# Power Supply Ripple and MDI Return Loss Modifications

GITESH BHAGWAT

ANALOG DEVICES

Figure 104-7—PSE ripple voltage test fixture

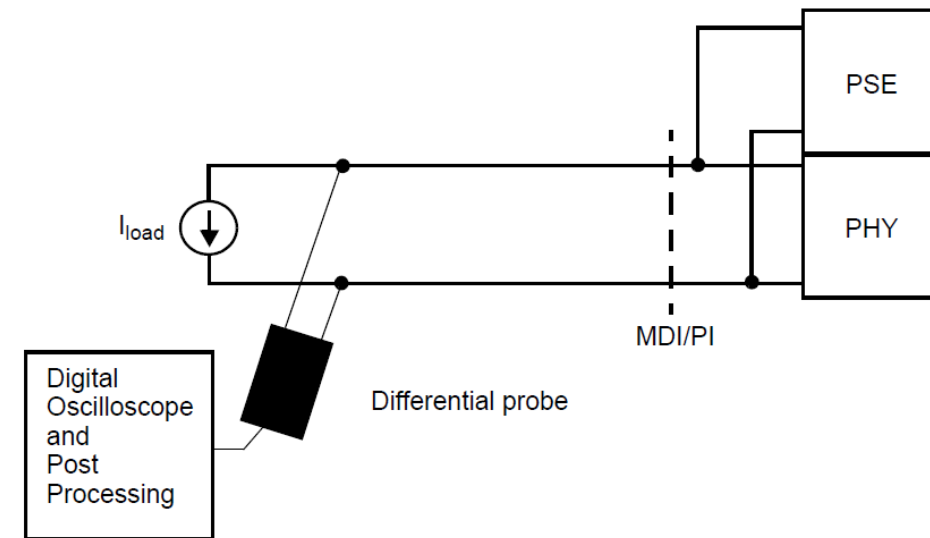
- ▶ For ripple measured at the MDI, a 100mV<sub>p-p</sub> limit is specified in Table 104-4 item 4a.

- ▶ For ripple seen at the PHY input, a 10mV<sub>p-p</sub> limit is specified in Table 104-4 item 4b.

- ▶ PAM4 (0.66V step) instead of PAM 3 (1V step)
  - Need more stringent PSE ripple specifications for NGAUTO systems
  - Scale peak ripple values from 0.1V to 0.066V for 4a and 0.01V to 0.0066V for 4b

- Since ripple is measured at MDI, the HPF cutoff frequency determined by the RC pole and should remain same
  - $f_1 = 318\text{kHz}$
- ▶ Internal PHY filter cutoff – do not shift this frequency for higher baud rate

- Consider same PHY pole as 1000BASE-T1 for all NGAUTO speeds
- ▶ Conclusion:
  - More stringent power supply specifications:
  - Lower peak to peak ripple voltage is allowed

- PHY filter is retained same as 1000BASE-T1 system
- ▶ Similar changes can be applied to PD ripple specifications

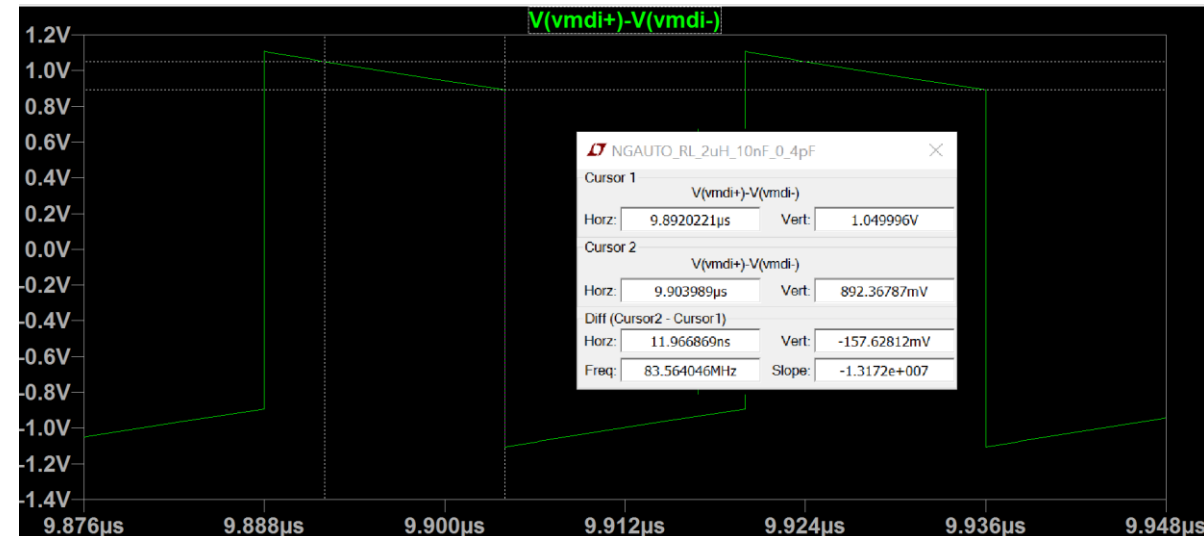
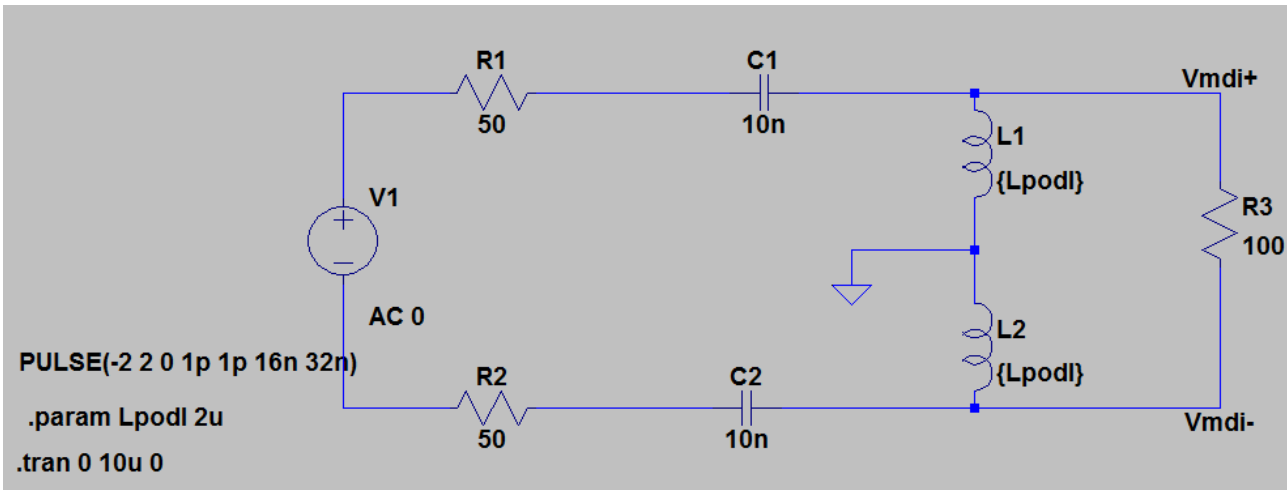
- ▶ Coupling circuit for droop simulation:
  - 2uH coupling inductor
  - 10nF coupling capacitor
- ▶ Droop calculated = 15%
  - $\text{Droop} = \frac{(1.0499 - 0.89236)V}{1.0499V} \times 100$  in 12ns
- ▶ Verify insertion loss HPF pole at 1.85Mhz
- ▶ Measure low frequency return loss for these values

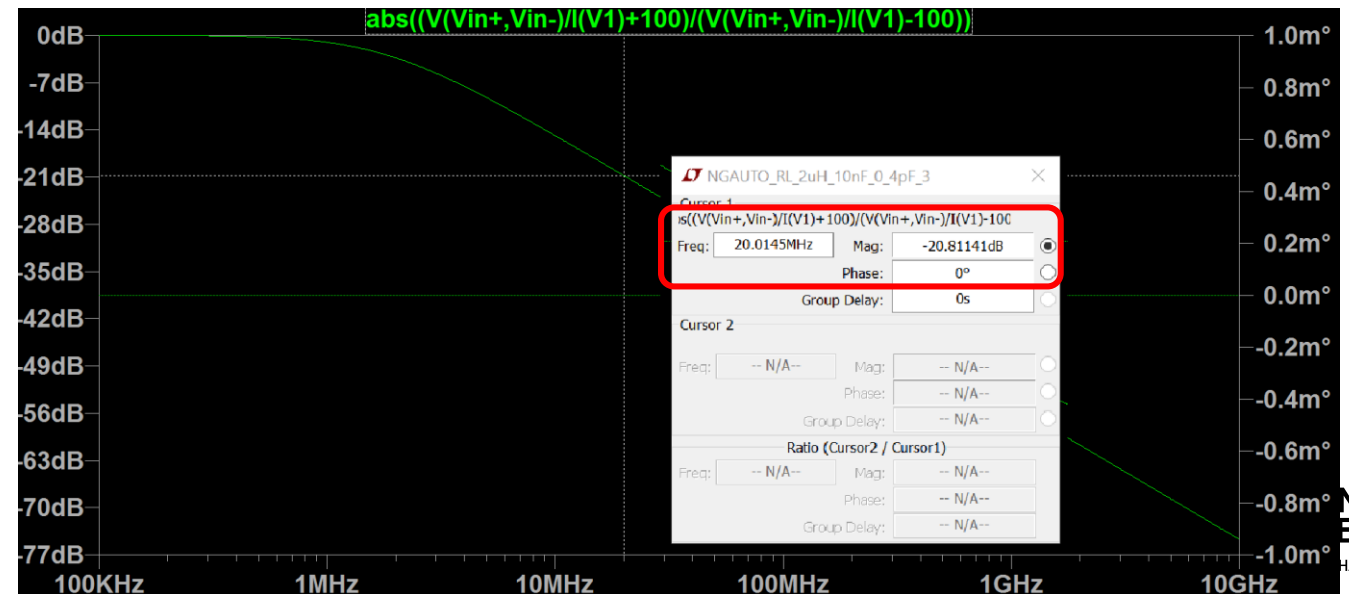
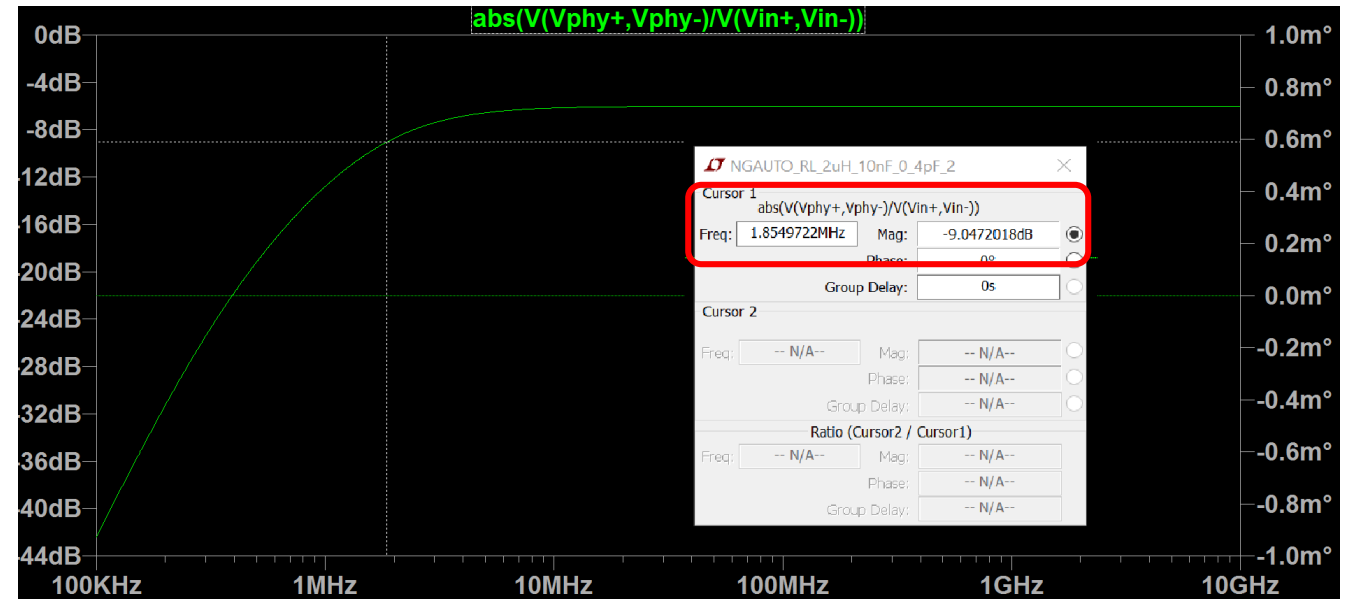
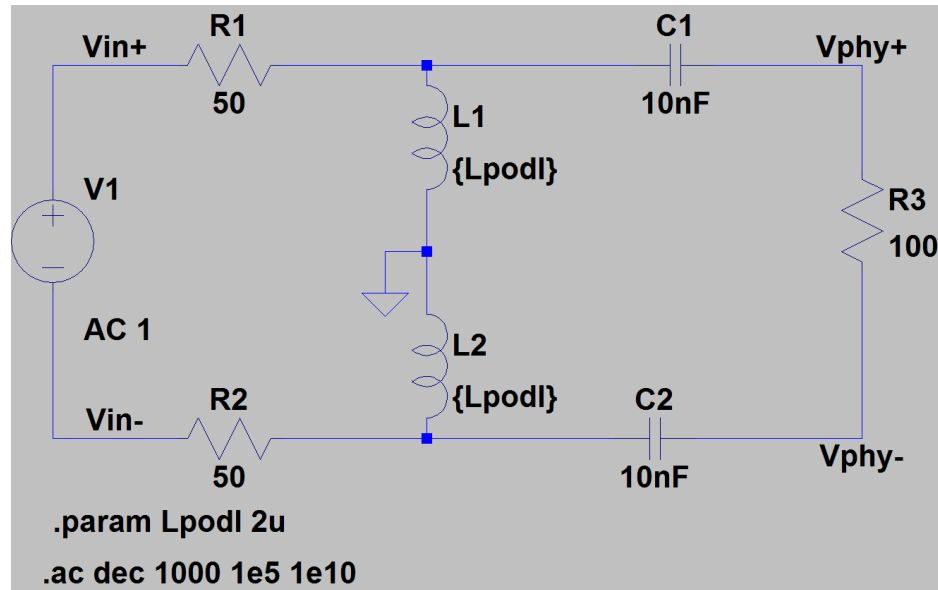
- ▶ HPF pole in insertion loss at 1.85 MHz verified
- ▶ Return Loss has a breakpoint of
  - -20dB at 20MHz
- ▶ Change the low frequency MDI return loss breakpoint to align with this

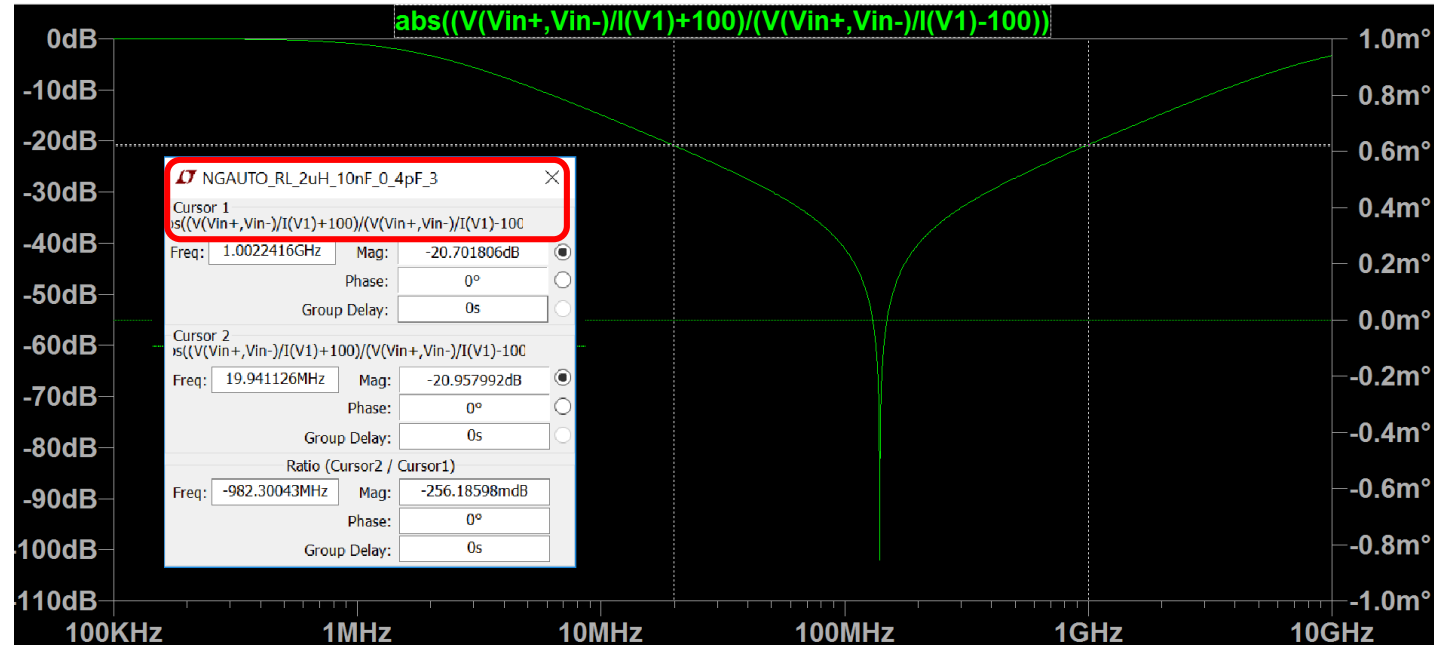
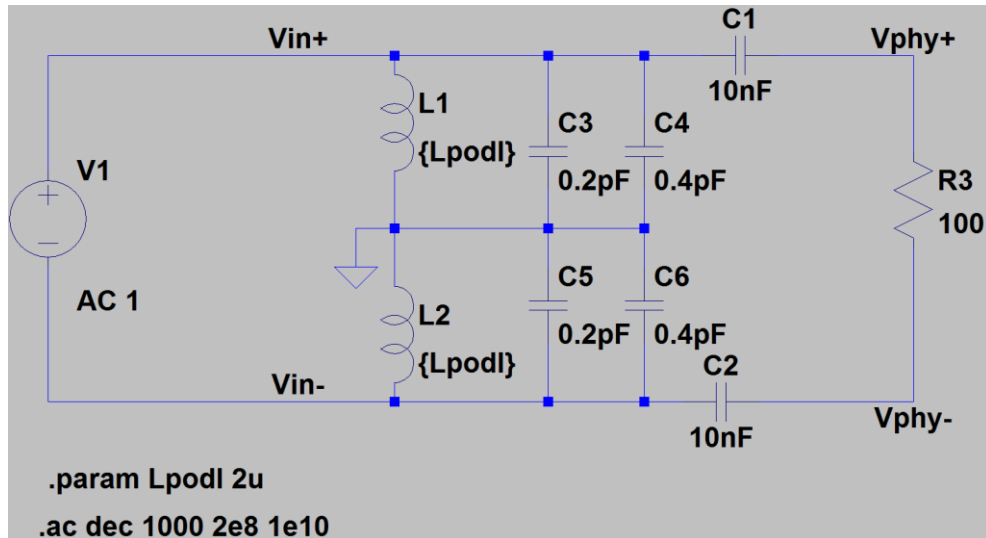
- ▶ Change the edit to clause 149.8.2.1 MDI return loss to change the low frequency breakpoint

$$MDI\_Return\_Loss(f) \leq \left\{ \begin{array}{ll} 20 - 20 \left( \log_{10} \frac{10}{f} \right) & 1 \leq f < 10 \\ 20 & 10 \leq f \leq 500 \\ 12 - 10 \log_{10}(f/3000) & 500 \leq f \leq 3000 \\ 12 - 20 \log_{10}(f/3000) & 3000 \leq f \leq 4000 \end{array} \right\} \text{ (dB)} \quad (149-27)$$

- **$20 - 20 \times \text{Log}_{10}\left(\frac{20}{f}\right)$**      **for  $2 \leq f \leq 20$**
- **20**     **for  $20 \leq f \leq 500$**
- $12 - 10 \times \text{Log}_{10}\left(\frac{f}{3000}\right)$      for  $500 \leq f \leq 3000$
- $12 - 20 \times \text{Log}_{10}\left(\frac{f}{3000}\right)$      for  $3000 \leq f \leq 4000$

MDI Return Loss Masks- Comparison

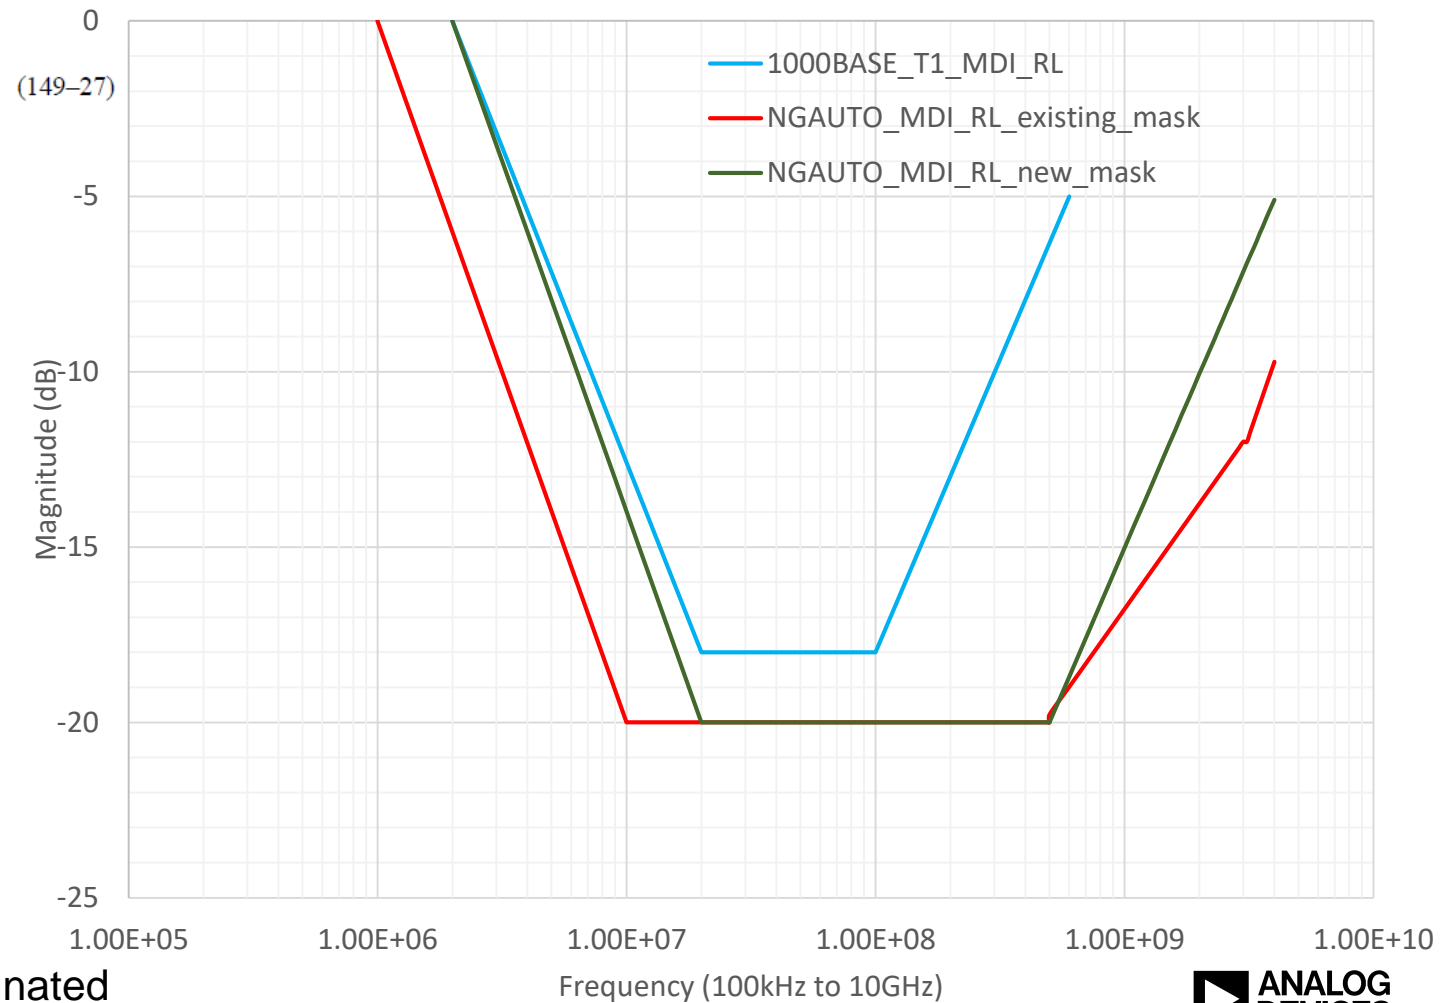
► Note: discontinuity in previous mask has been eliminated

- $20 - 20 \times \text{Log}_{10}\left(\frac{20}{f}\right)$  for  $2 \leq f \leq 20$
- $20$  for  $20 \leq f \leq 500$
- $20 - 16.5 \times \text{Log}_{10}\left(\frac{f}{500}\right)$  for  $500 \leq f \leq 4000$
